Village of Chenequa Plan Commission  
Monday, June 9, 2025 at 6:00 p.m.  
31275 W. County Road K, Chenequa, WI 53029

## STAFF REVIEW

**Subject:** Site Plan Review

**Project Description:** Proposed Accessory Structure

Shoreline Landscape	Chris Miracle, PLA, ASLA	Date: 4.16.25	Rev: 5.2.25
	John Klatt, PLA, ASLA		
	Sheet Number: 2/3

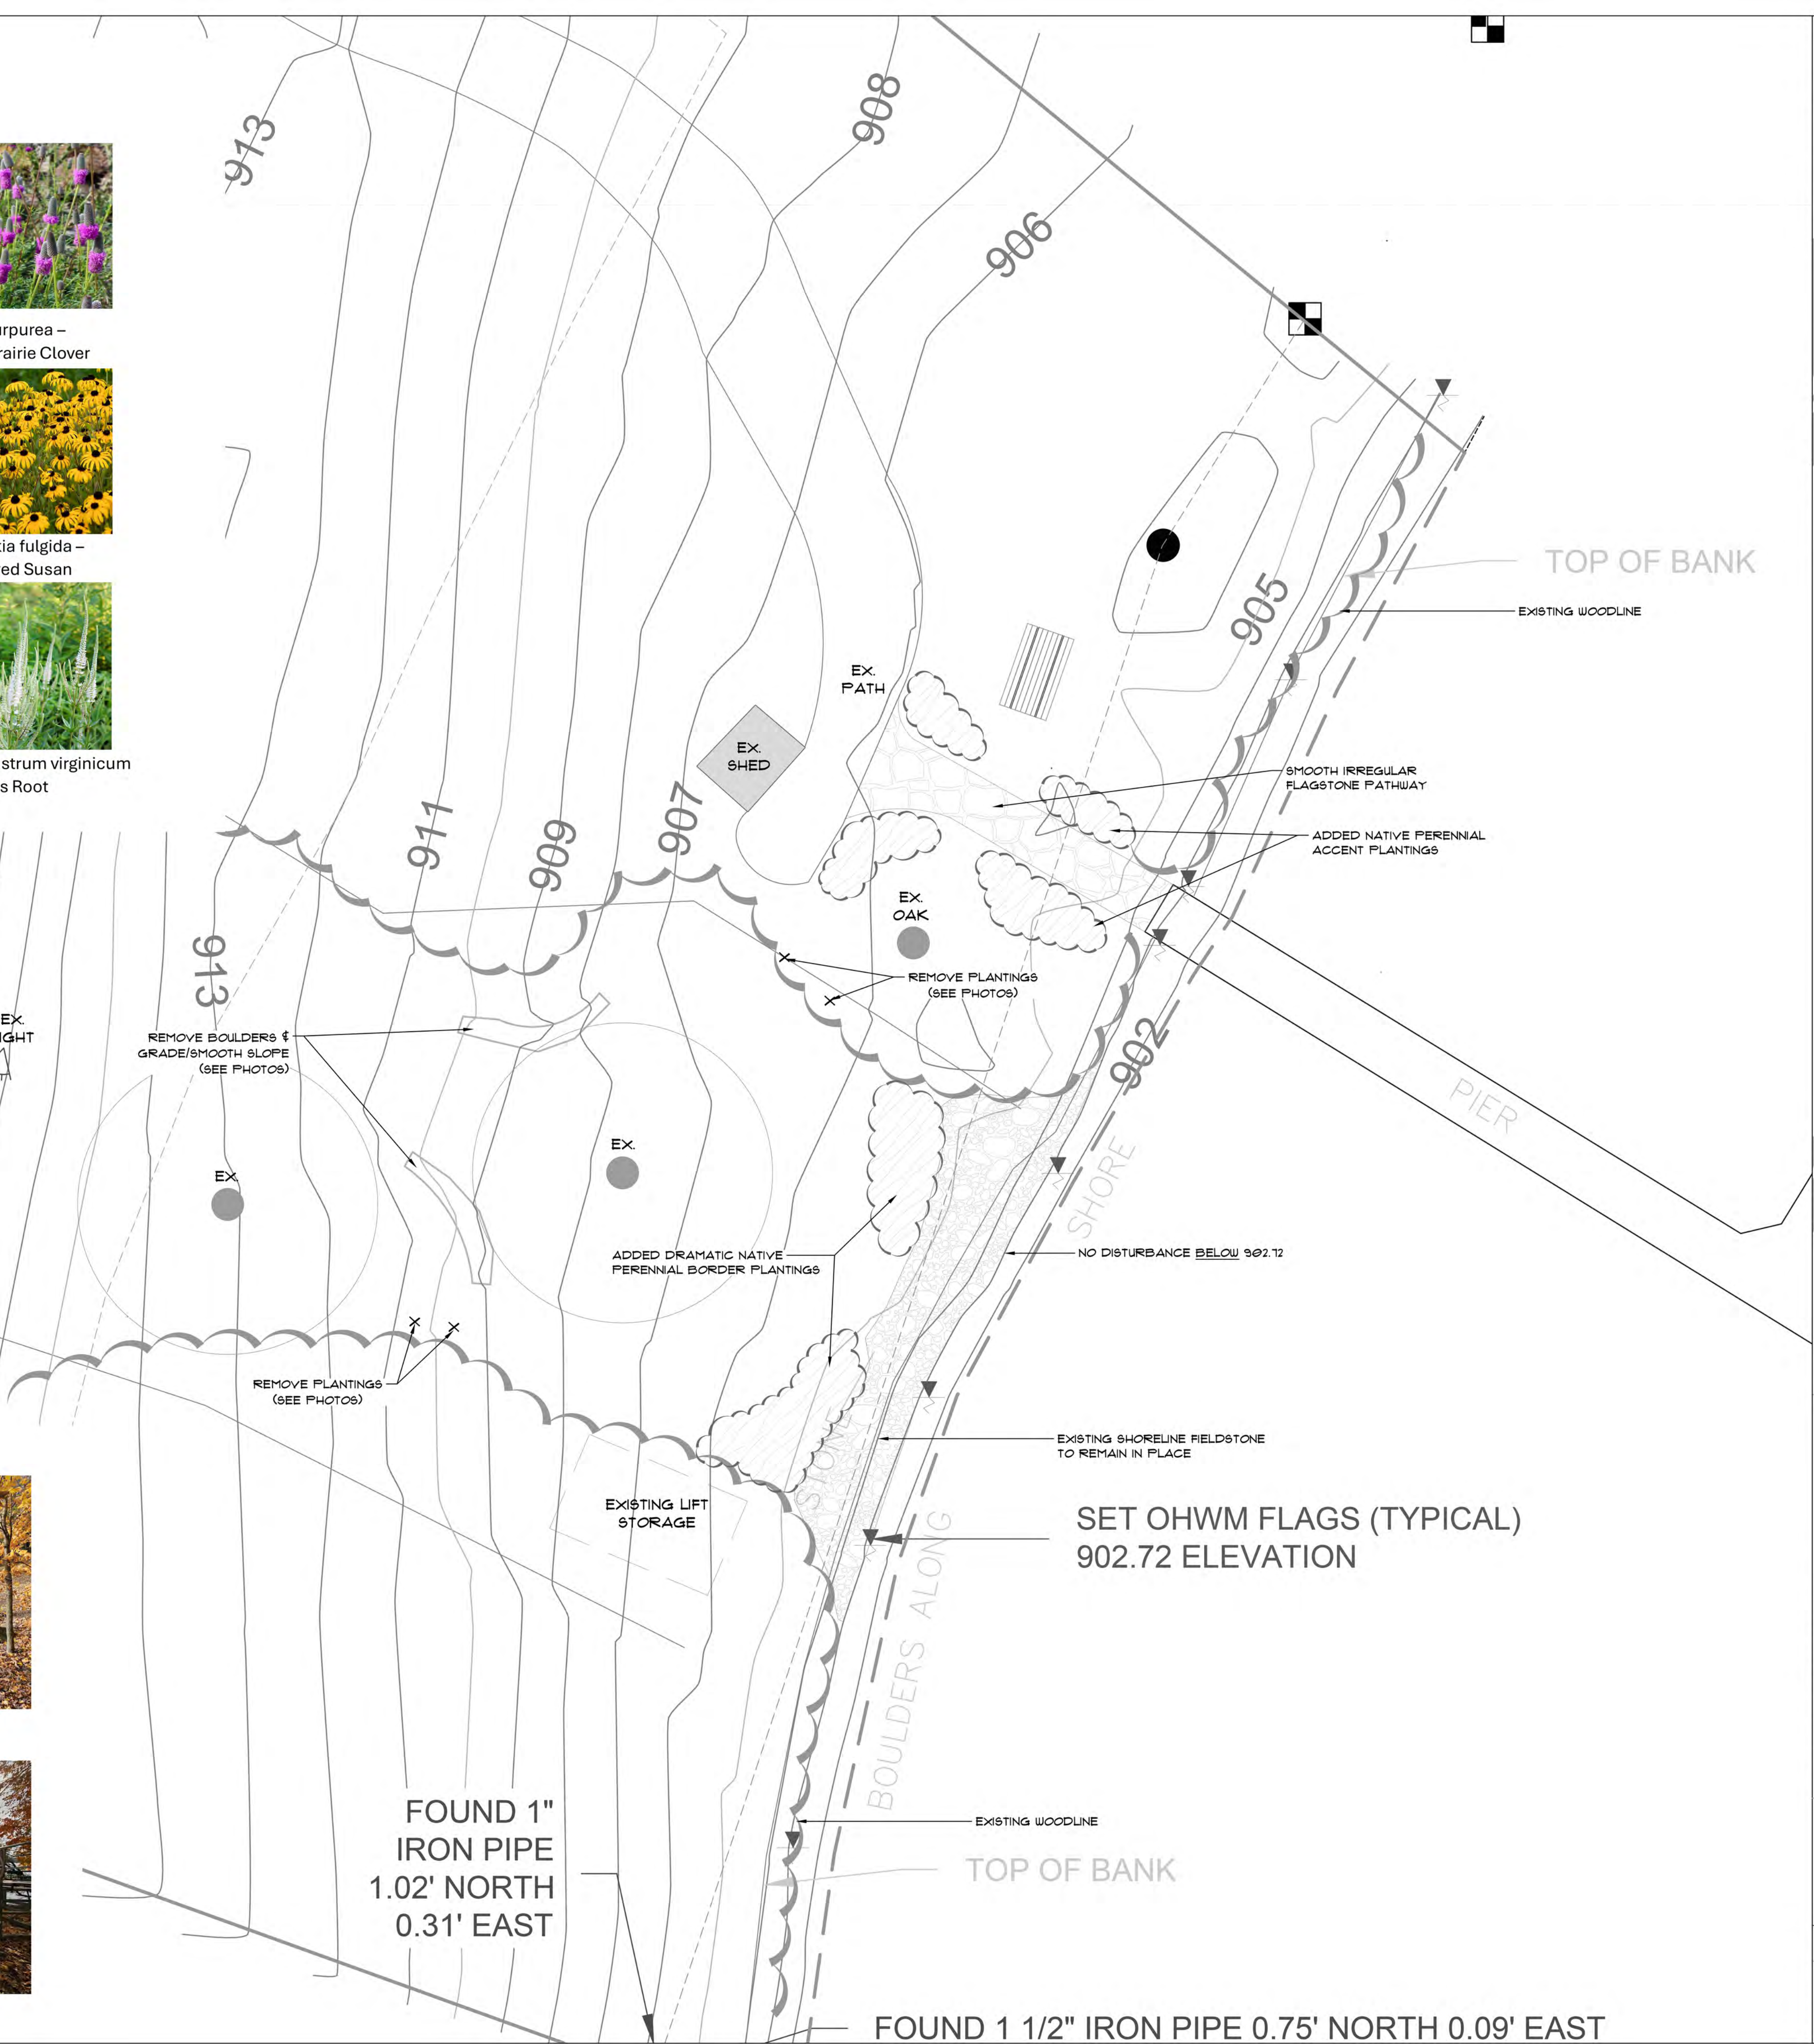
1. The applicant proposes landscaping on the lake side of the primary dwelling.
2. Plans include, adding a path, adding plantings and removing existing landscaping
  - a. Proposed path
    - i. The path is proposed to be constructed of flagstone steppers set at soil grade.
    - ii. The proposed path will connect an existing cart path to the existing pier on the property
    - iii. See landscape drawing for proposed path location.
    - iv. The proposed path will not exceed 4' in width
    - v. A photo sample has been provided in the included packet
  - b. Proposed plantings
    - i. Along the proposed path and shorefront the applicant proposes to add native perennial plantings

- ii. Proposed planting locations are provided in the landscape plan
    - iii. Photo samples of proposed plantings have been provided in the packets
  - c. Removal of existing landscaping
    - i. The landscape plan also proposes to remove existing boulders near the shorefront.
    - ii. Location of existing boulders are provided in the landscape plan
- 3. A cutting permit must be obtained by the Village Forester before existing ground cover may be removed.

SCALE: 1/8" = 1'-0"  
SHEET NUMBER: L1.1

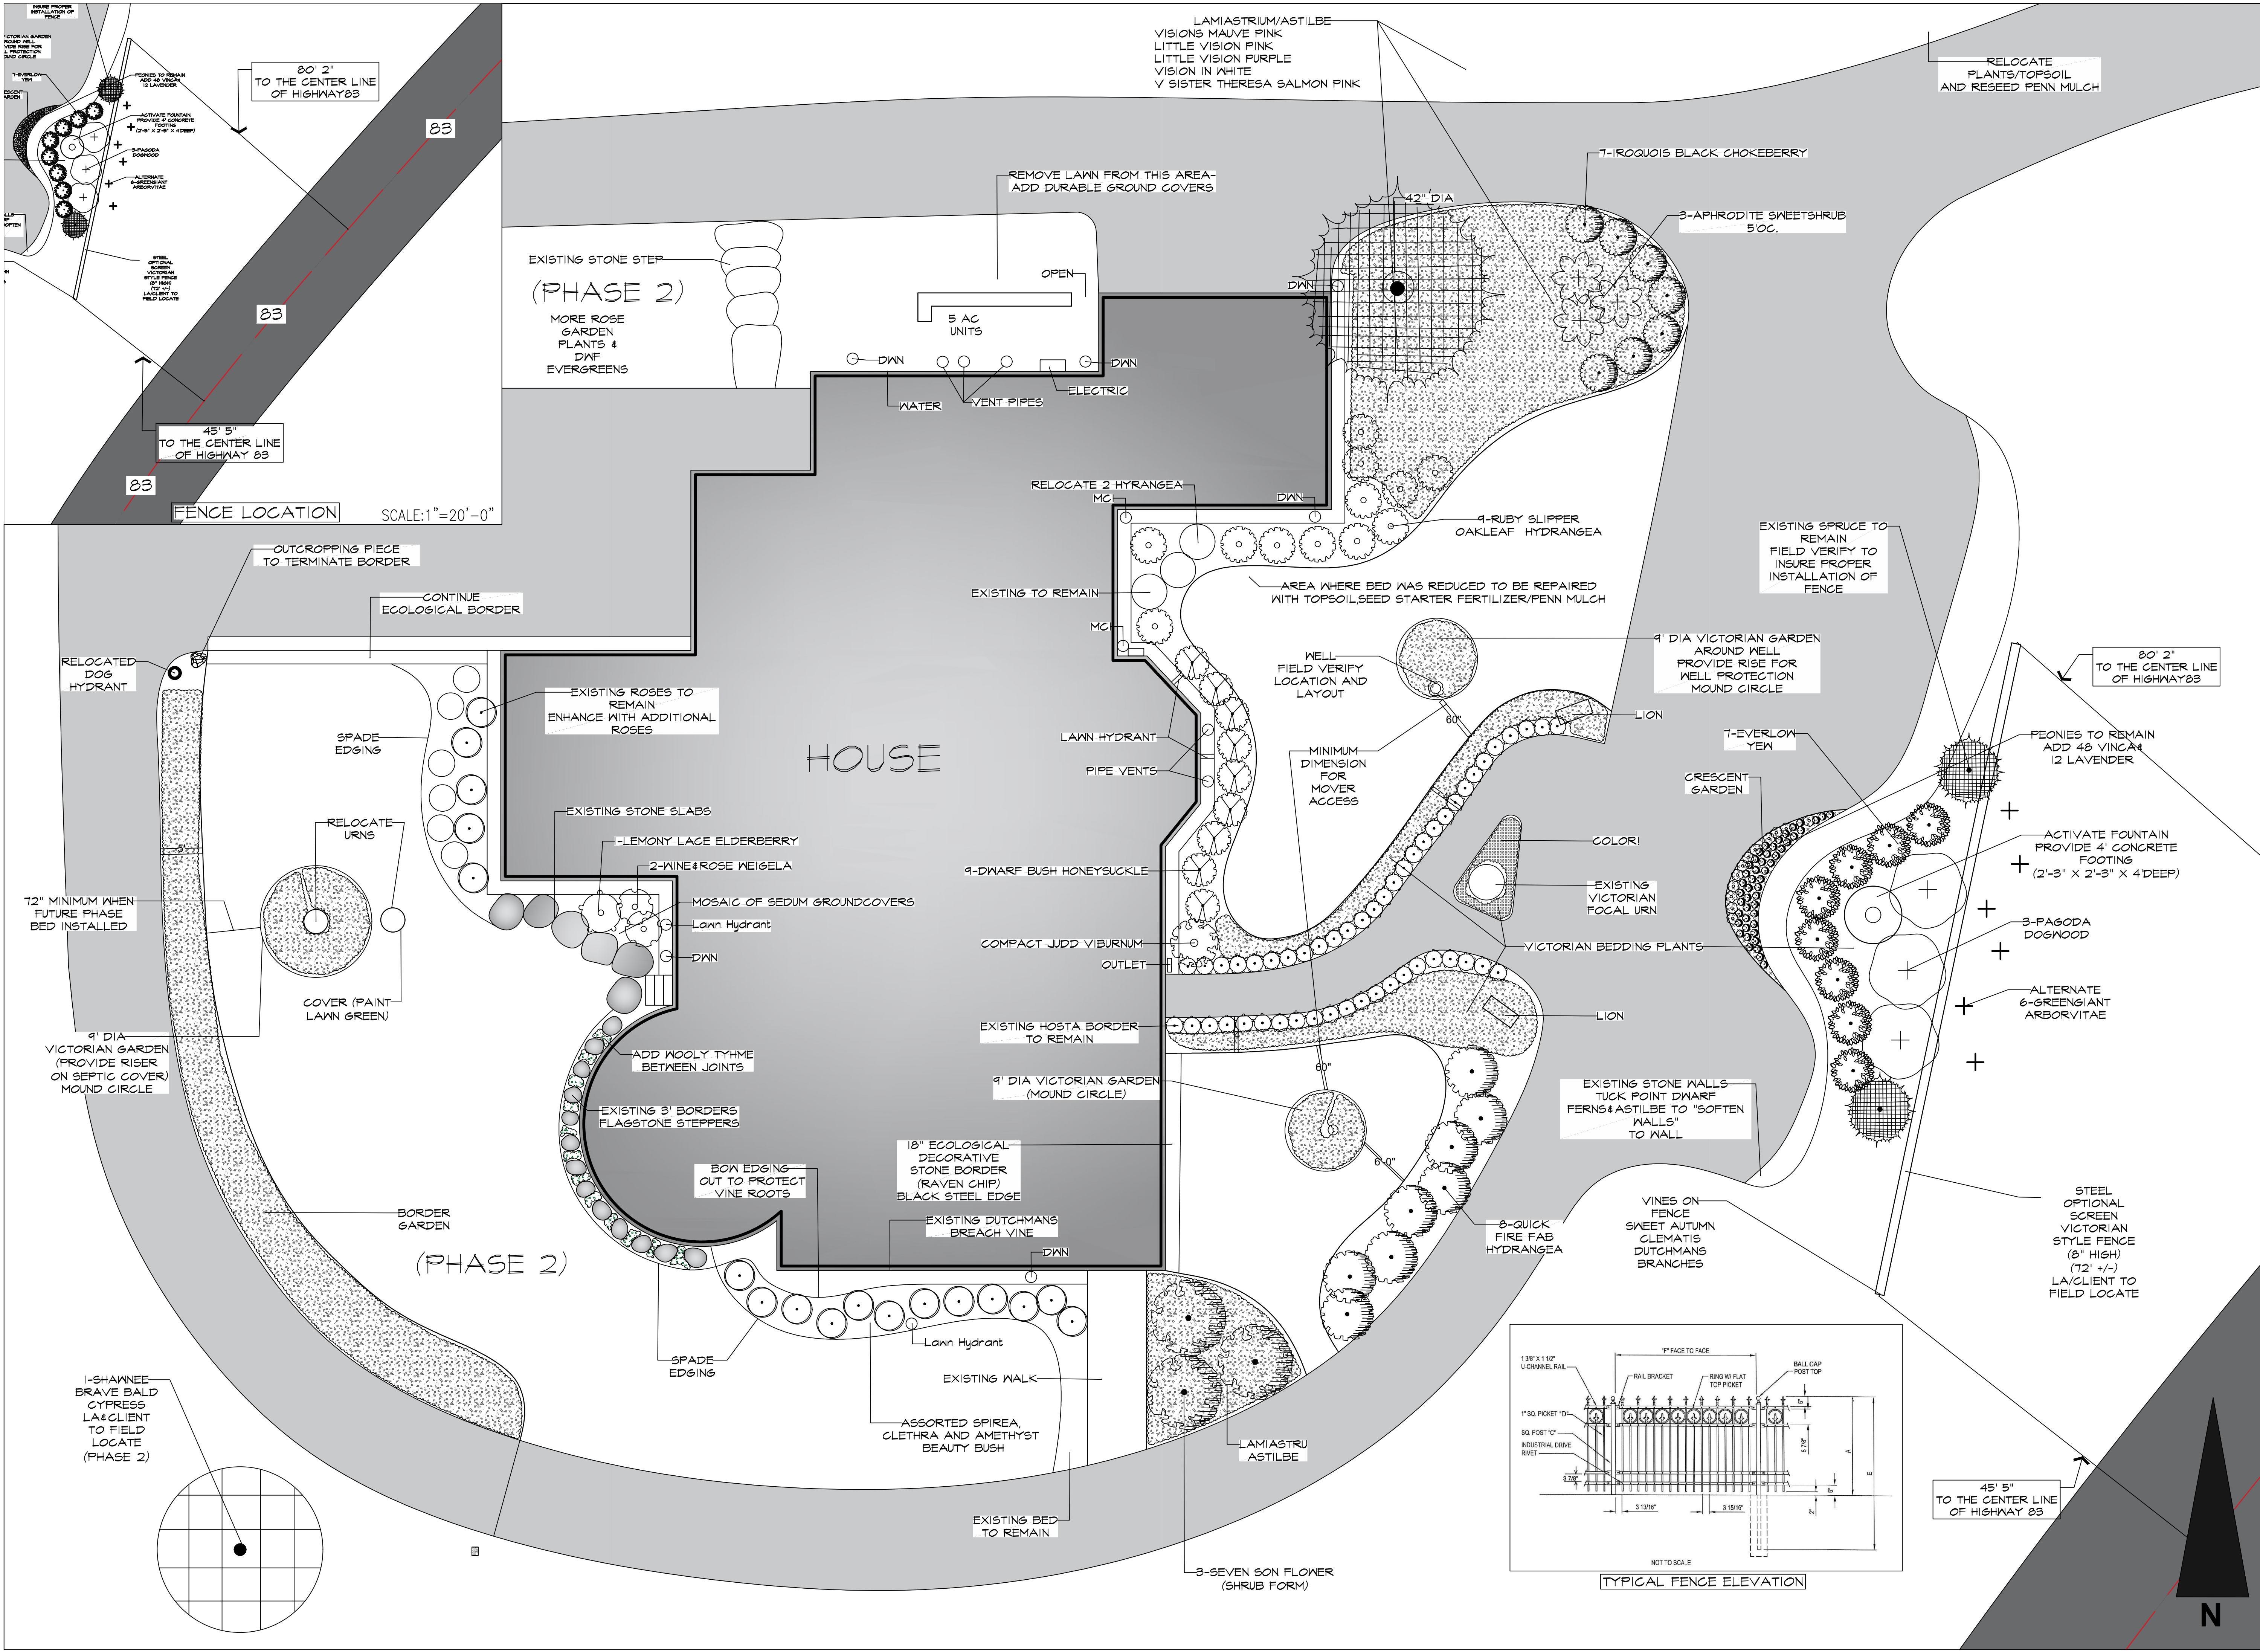
1. The applicants are proposing to construct an 8' fence along STH 83 to serve as additional screening from the road
2. According to 5.20(1) *"All permit applications shall be referred to the Plan Commission and shall be considered as to appearance, materials, design, location, height and harmony of the proposed fence with the principal structure on the lot and structures on neighboring lots so as not to adversely affect property values in the neighborhood."*

3. The fence is proposed to be a "Steel Victorian Style Fence"
  - a. A sample sketch of the proposed fence has been provided in the attached landscape plan

- b. Fence location has also been provided on the landscape plan
4. At the nearest point, this proposed fence is set back 45' 5" from the centerline of STH 83 (Approximately 12.5' feet outside of the public right of way (refer to site drawing in packet)).
